Access Compliance Report

Public Rights-of-Way

(Curb Ramps)

Intersection ID: 12937	Main Street: E_W_T_HARRIS_BV	Cross Street: HICKORY_GROVE_RD	Location: W
ADA ID: AF52FC69D5EA	Ramp Type: Perp	Initial Pass/Fail: Fail	Overall Compliance: No
Severity Score: 8.75			
Codes/Mitigation Info/Possible Solution		Field Measurements/Component Compliance

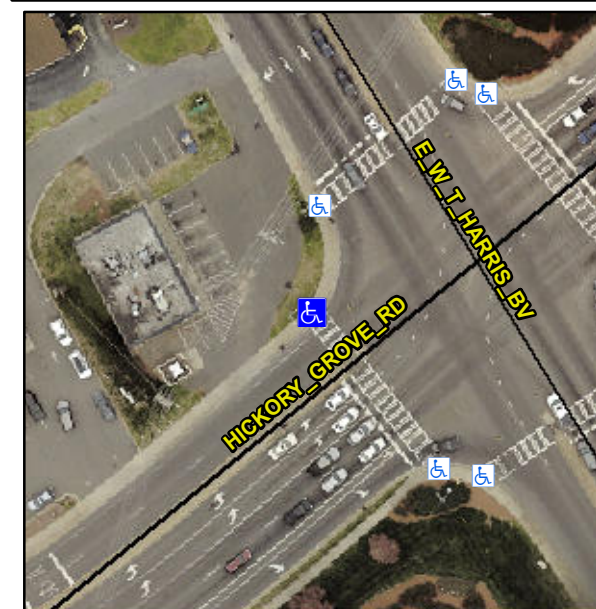
Not Found, R304.5.1

Compliance	Description	Data	Compliance	Description	Data
N/A	Ramp Length (in)	73.0	Yes	Ramp Slope (%)	7.9
No	Ramp Width (in)	37.5	Yes	Ramp XSlope (%)	0.9
N/A	Flare Type LT	N/A	N/A	Flare Type RT	N/A
N/A	Flare Slope LT (%)	N/A	N/A	Flare Slope RT (%)	N/A
N/A	Flare Traversable LT?	N/A	N/A	Flare Traversable RT?	N/A
N/A	Landing Length (in)	N/A	N/A	DWS Provided?	N/A
N/A	Landing Width (in)	N/A	N/A	DWS Contrast?	N/A
N/A	Landing Slope (%)	N/A	N/A	DWS Length (in)	N/A
N/A	Landing X Slope (%)	N/A	N/A	DWS Full Width?	N/A
N/A	Landing Curb? (Y/N)	N/A	N/A	DWS Offset (in)	N/A
N/A	Shared Landing?	N/A			
N/A	Gutter Ponding?	Yes	N/A	Gutter Slope (%)	N/A
N/A	Gutter Lip Ht (in)	N/A	N/A	Gutter X Slope (%)	N/A
N/A	Painted X Walk1?	Yes	N/A	Painted X Walk2?	N/A
	X Walk 1 Direction	To SE		X Walk 2 Direction	N/A
N/A	X Walk 1 Width (in)	123.0	N/A	X Walk 2 Width (in)	N/A
	X Walk 1 Slope (%)	2.2		X Walk 2 Slope (%)	N/A
	X Walk 1 X Slope (%)	1.0		X Walk 2 X Slope (%)	N/A

Remove & Replace Entire Ramp.
